CITY OF MERCED
DEPARTMENT OF ENGINEERING
678 W. 18th Street, Merced, CA 95340

ADDENDUM NO. 1

BEL AIR SEWER LINE
PROJECT NUMBER CP 220033

3 REPLACEMENT OF (E) WATER MAIN AT (N) SEWER MAIN CROSSING

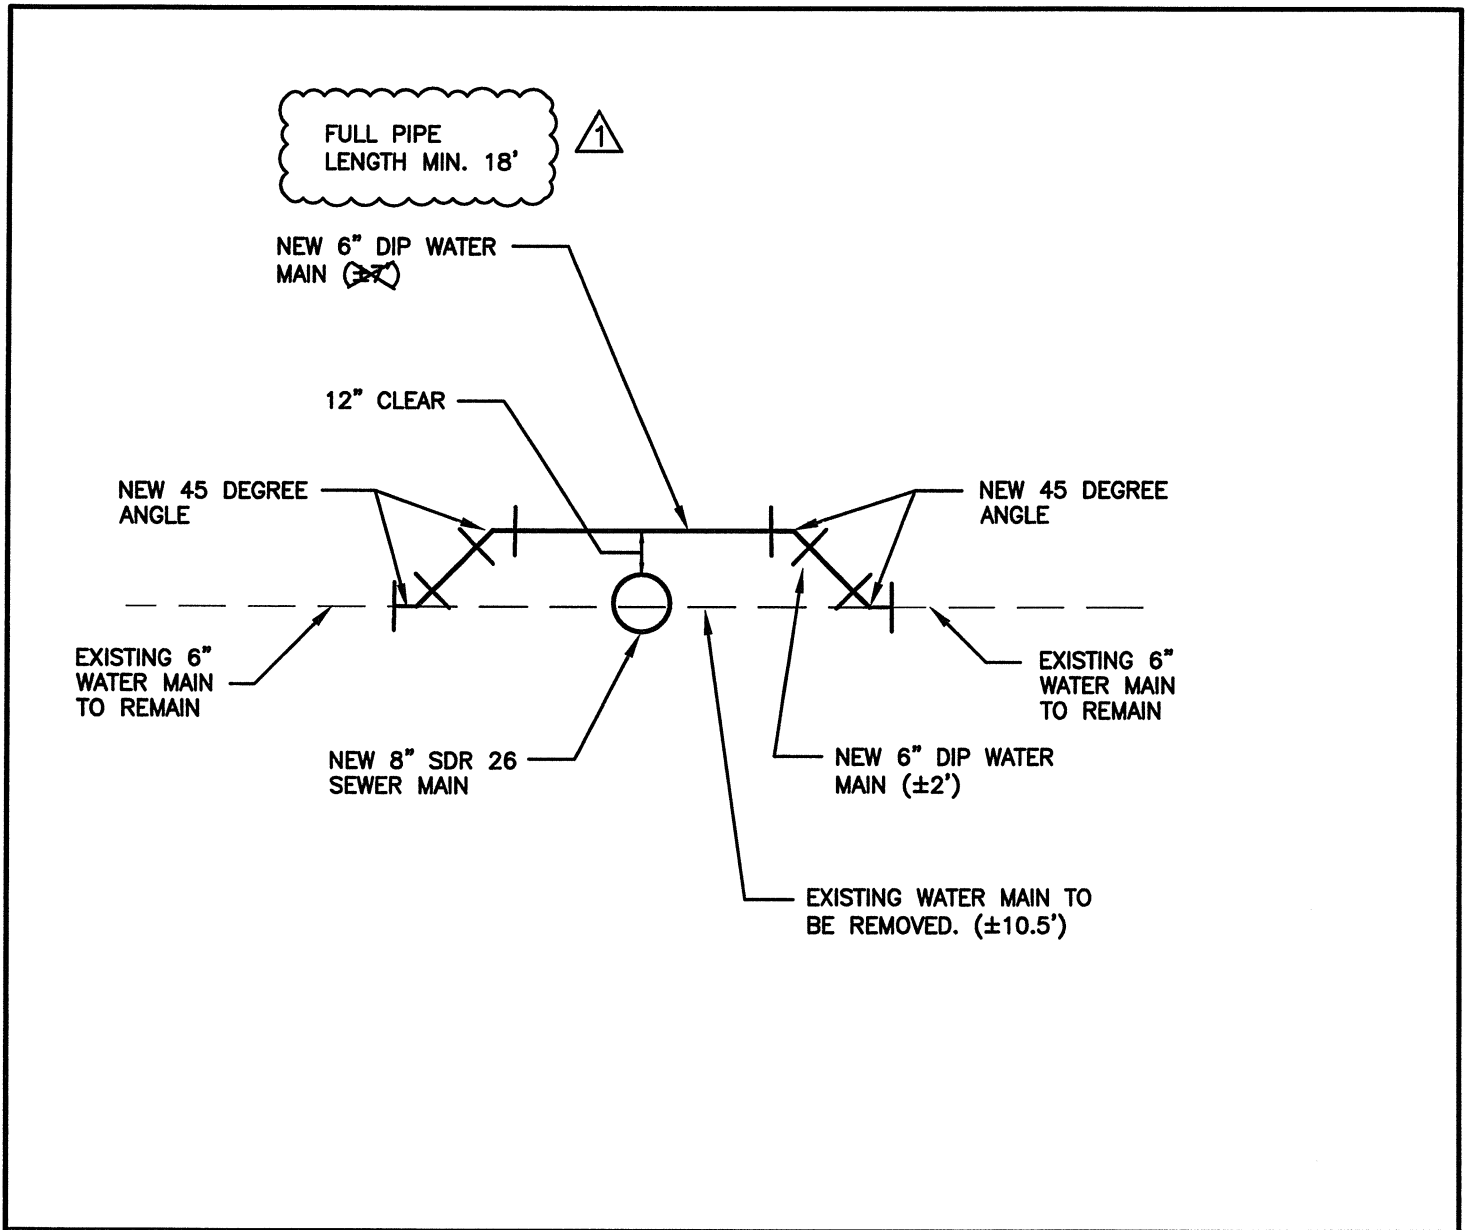
Item 2 PLANS: - Detail 3, Sheet 5 and Detail 3, Sheet 7

Revise Details to show a minimum of an eighteen-foot span (18') centered over the sewer main per attached drawing.
